SUBMISSION TO THE PYRMONT PENINULA SUB-PRECINCT MASTER PLANS

Thank you for providing the opportunity to make a submission on the draft Pyrmont Peninsula Sub-Precinct Master Plans and accompanying documents. This submission has been prepared by Ethos Urban on behalf of Poulos Bros, as owner of the site at 21-28 Bank Street, Pyrmont.

Submitted to NSW Department of Planning,
Infrastructure & Environment

Figure 2 Suggested Master Plan approach to land use
 Source: Ethos Urban

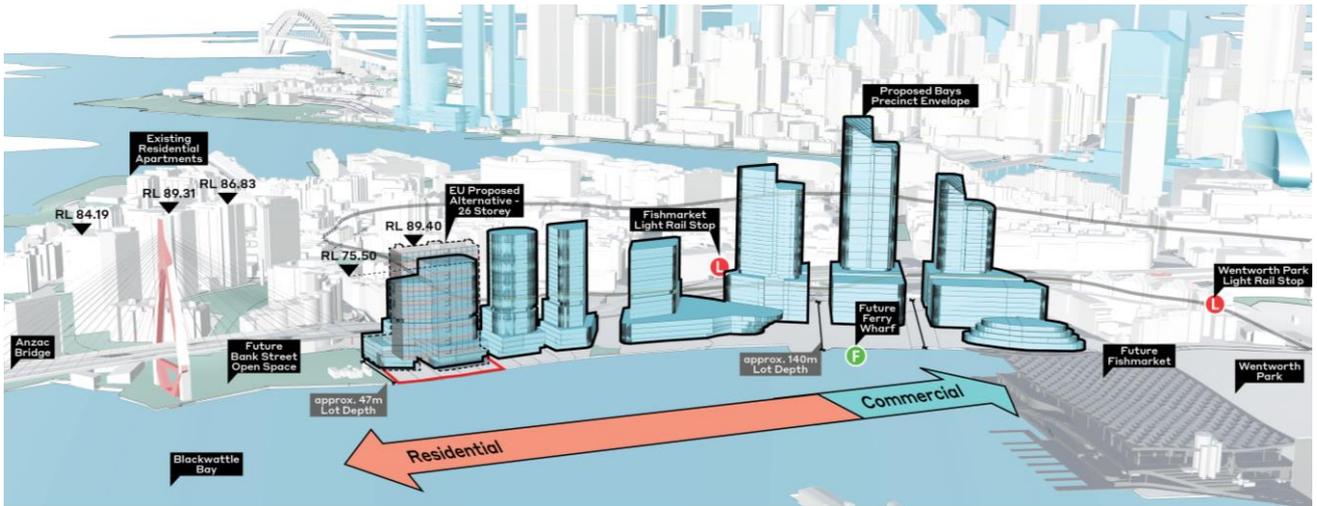
We therefore seek that the final Sub-Precinct Masterplans directly cite the RLs established by Jacksons Landing for context. We refer you to the submission made to the SSP at Appendix A for further detail and justification of this point.

Figure 3 Open Space identification

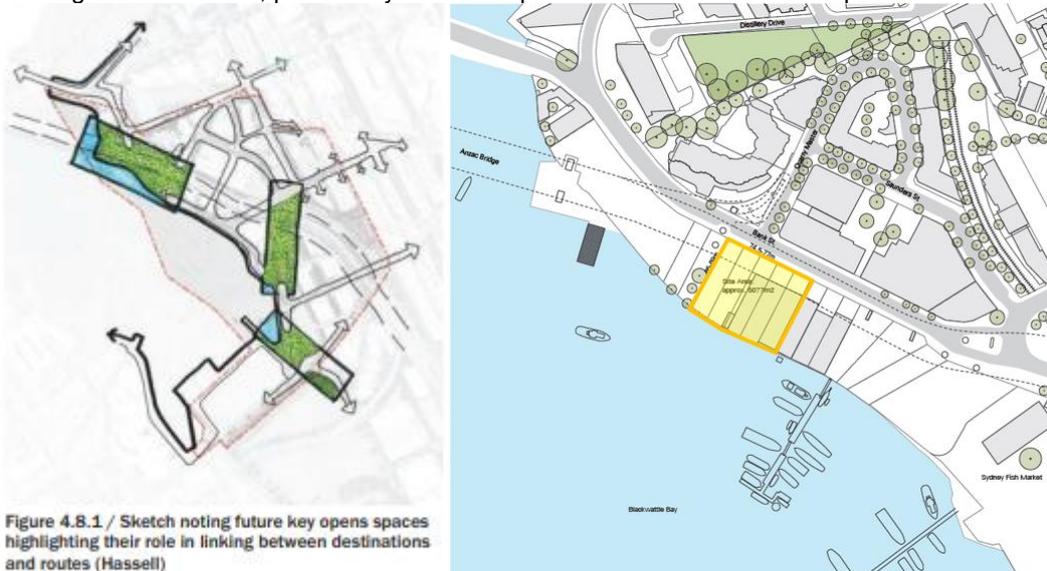
We seek clarification of the HASSELL Urban Design document that perhaps misinterprets land ownership patterns in its Figure 4.8.1 below, particularly when compared with the land ownership of Poulos shown adjacent

This then is transferred to the Blackwattle Bay Sub-Precinct Structure Plan (Figure 4.8.4) which then places a large swathe of open space over the Poulos site.

Figure 2 The Poulos Bros site harbour interface

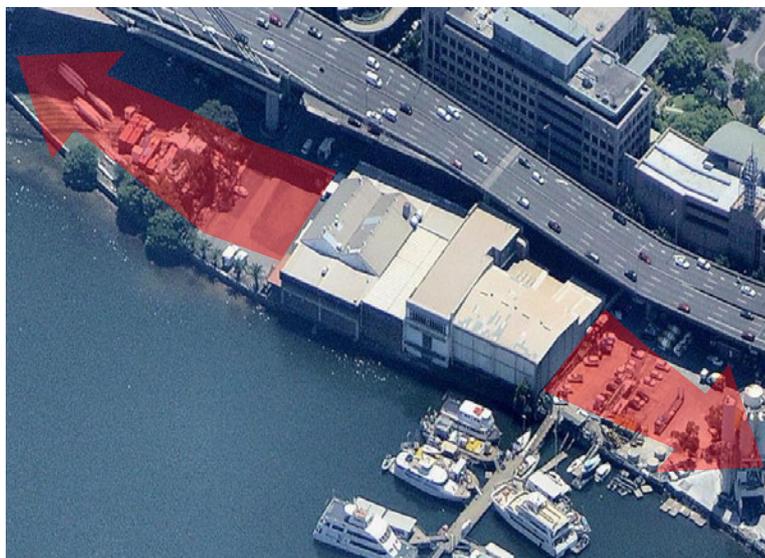
As shown in **Figure 2**, should redevelopment of the Poulos Bros site not occur, any hope of a continuous and connected harbour foreshore walk may not be achieved. If a feasible outcome is not reached, Poulos Bros will continue to operate at the site.

Figure 3 Sites capable of change & Taller Building clusters
 Source: Hassell, July 2020

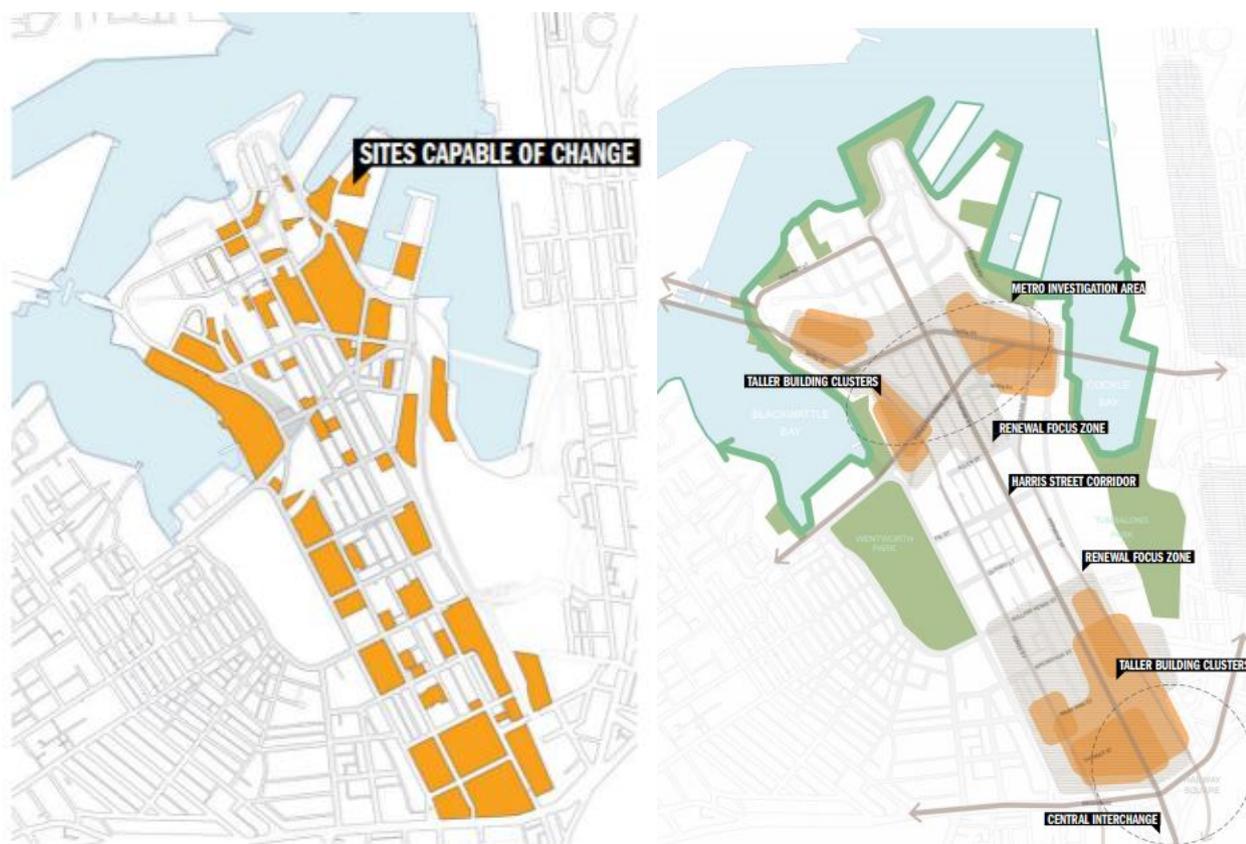
However, the capability to accommodate change has not translated to the opportunity areas for taller building clusters (**Figure 3**). The taller building cluster excludes the Poulos Bros site, including land immediately opposite, on the northern boundary of Bank Street. There is no technical evidence that supports this direction. The northern part of Bank Street upholds the same level of strategic value and is exposed to the same accessibility constraints as the Poulos Bros site. This land is also within the vicinity of the Anzac Bridge pylons and therefore should be treated equally in terms of respect for heritage.

It is evident that this is not the case and therefore Poulos Bros question why their site has been excluded from the tower cluster when DPIE have recognised the site is capable of change.

Poulos Bros note that the harbour foreshore walk has been included in the tower cluster opportunity map. Again, if a feasible outcome is not reached, Poulos Bros will continue to operate at the site and a harbour foreshore walk cannot be delivered. Further, the under-bridge activation sought in the plan, as well as the activation of the foreshore will not be delivered if adequate GFA is not allowed at the site.

Figure 8 Light Rail proximity
 Source: Ethos Urban

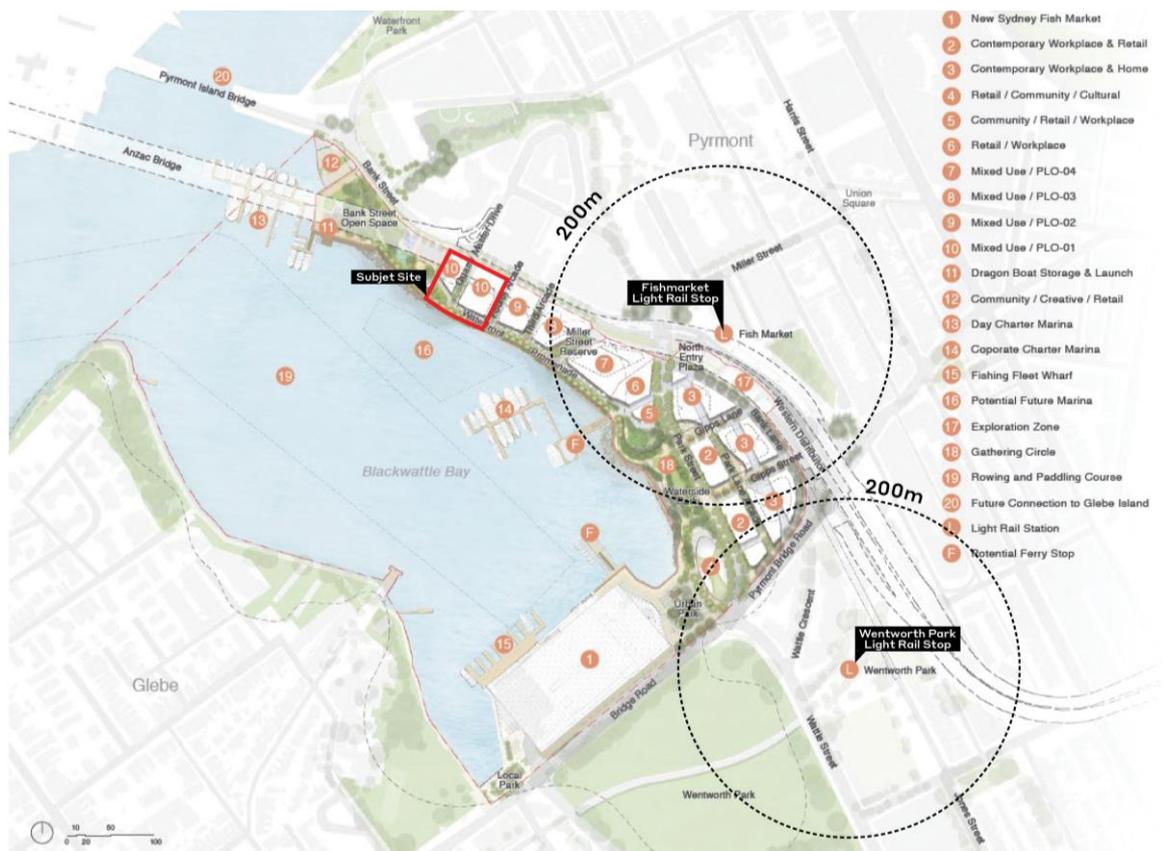
- Commercial land uses should be located proximate transport linkages. This is a long standing and undisputed integrated land use and transport planning principle. The Government land is nearer the planned Metro at Union Street and the existing Light Rail stops as well as the planned ferry and existing major road network. This is demonstrated in **Figure 8** below.

Figure 10 Height Study: Revitalising Blackwattle Bay

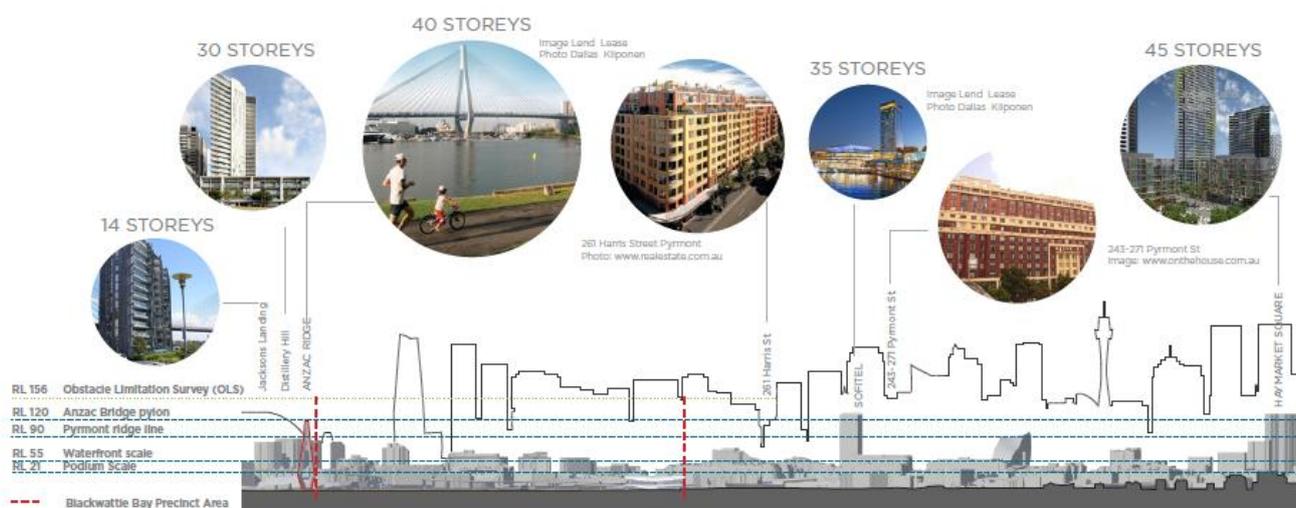
The original principle of no overshadow to the foreshore/parks seems to have been reinvented. **Figure 10** below is taken from the June 2020 INSW document “Revitalising Blackwattle Bay”, which again put forward the key principle guiding height being to ‘Minimise additional overshadowing to Wentworth Park and Glebe Foreshore between 9am and 3pm on the winter solstice’

Figure 15 Jacksons Landing height reference
Source: Ethos Urban

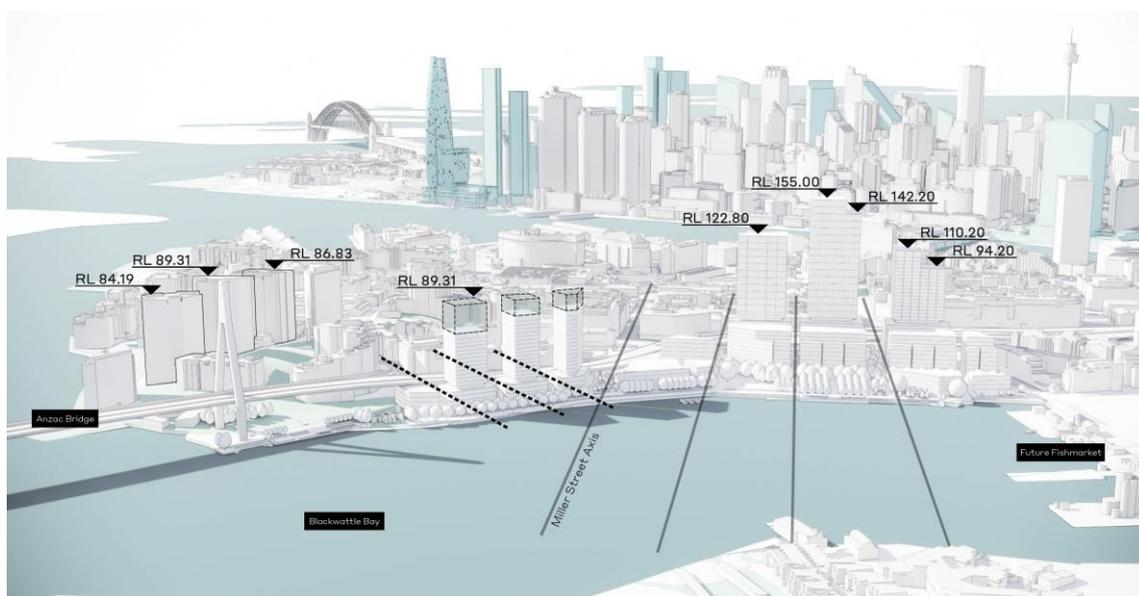
As discussed, there is no adequate justification for the reduction in height for the Poulos site. In terms of local context, the site can accommodate RL90 and comfortably sit amongst the tall building cluster of Jacksons Landing. It is worth noting that these buildings were approved some 30 years ago – and that an evolving international City such as Sydney would anticipate greater heights than those approved 30 years ago. This is shown clearly in **Figure 14** and **Figure 15** below.

Figure 4 Sites capable of change & Taller Building clusters

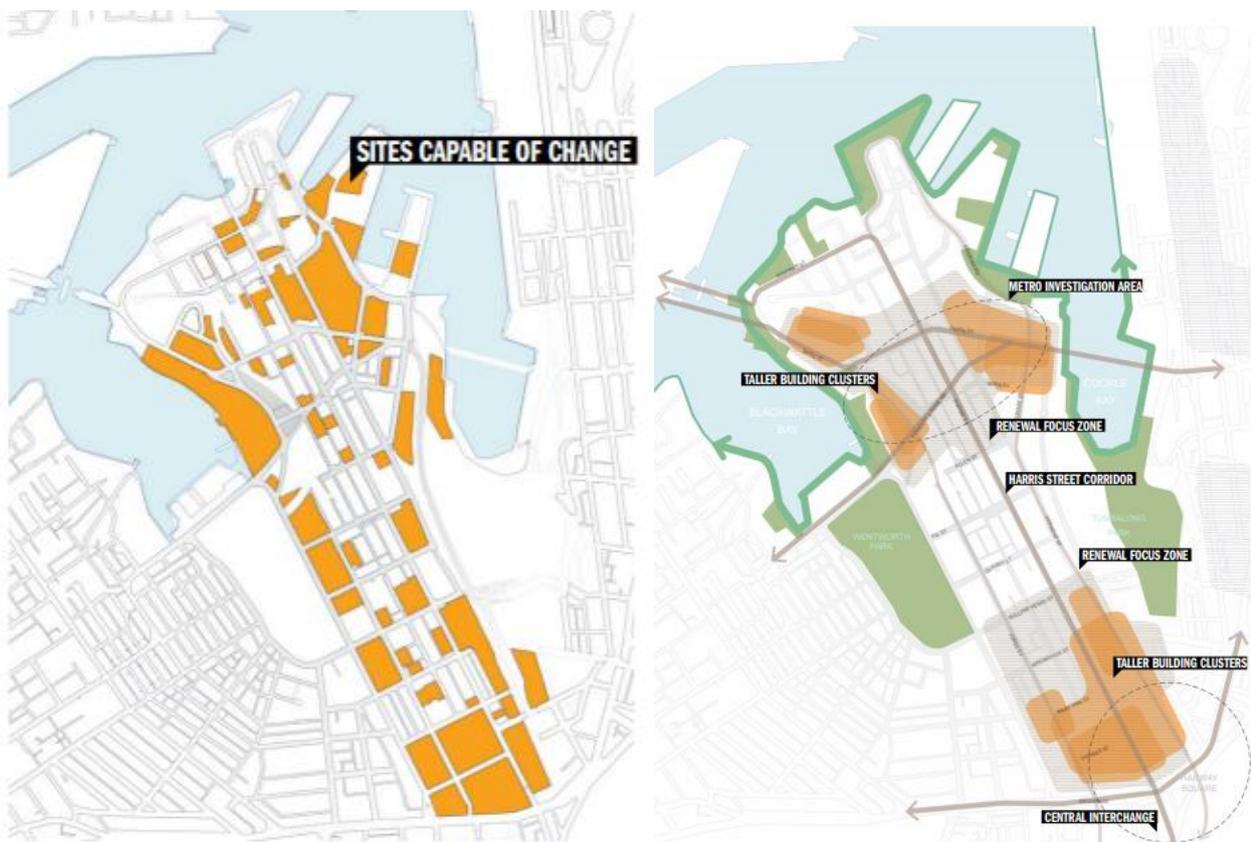
However, the capability to accommodate change has not translated to the opportunity areas for taller building clusters (Figure 4). The taller building cluster excludes the Poulos Bros site, including land immediately opposite, on the northern boundary of Bank Street. There is no technical evidence that supports this direction. The northern part of Bank Street upholds the same level of strategic value and is exposed to the same accessibility constraints as the Poulos Bros site. This land is also within the vicinity of the Anzac Bridge pylons and therefore should be treated equally in terms of respect for heritage.

Poulos Bros note that the harbour foreshore walk has been included in the tower cluster opportunity map. Again, if a feasible outcome is not reached, Poulos Bros will continue to operate at the site and a harbour foreshore walk cannot be delivered. Further, the under-bridge activation sought in the plan, as well as the activation of the foreshore will not be delivered if adequate GFA is not allowed at the site.
